# Work Order ID 97428

Item Name: Crosstube Fwd

DRAWING NO. D407-667-145	TITLE CROSSTUBE ASS'Y (407 HIGH FWD)	REV. C	<b>DART AEROSPACE LTD ENGINEERING ORDER</b>		D.E.O. NO. D407-667-145-C-1	SHEET NO. SHEET 1 OF 1	SCALE NTS
DRAWN <i>q</i>	CHECKED <i>ASS</i>	MFG. APPR. <i>IB</i>	APPROVED <i>WD</i>		DE APPR. <i>HA</i>		
DATE 11.07.15	DATE 11.07.22	DATE 11.07.22	DATE 11/07/22		DATE 11.07.21

**DETAIL P**  
BONDING STRAP INSTALLATION 2 PL

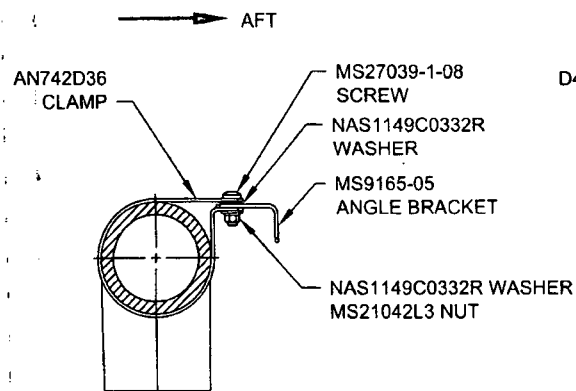
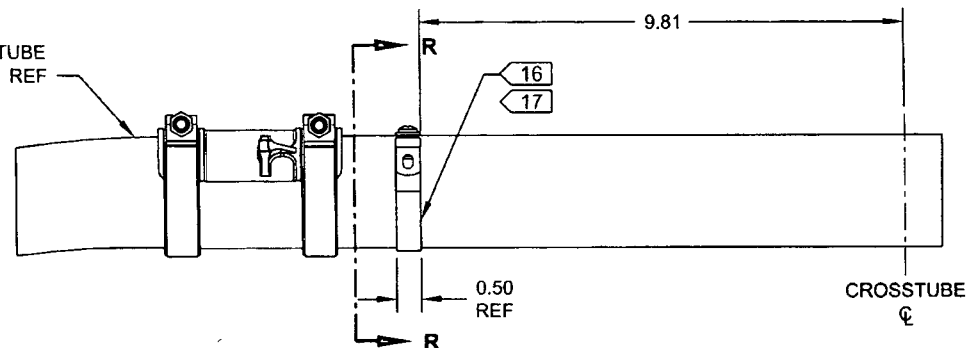
ADD ELECTRICAL GROUNDING STRAP

ADD

ADD

ITEM	QTY -145	PART NUMBER	DESCRIPTION
1	X	D407-667-145	CROSSTUBE ASSEMBLY (407 HIGH FWD)
10	2	AN742D36	CLAMP
11	2	MS9165-05	ANGLE BRACKET
12	2	MS21042L3	NUT (OR MS21042-3)
13	2	MS27039-1-08	SCREW
14	4	NAS1149C0332R	WASHER (OR AN960C10L)
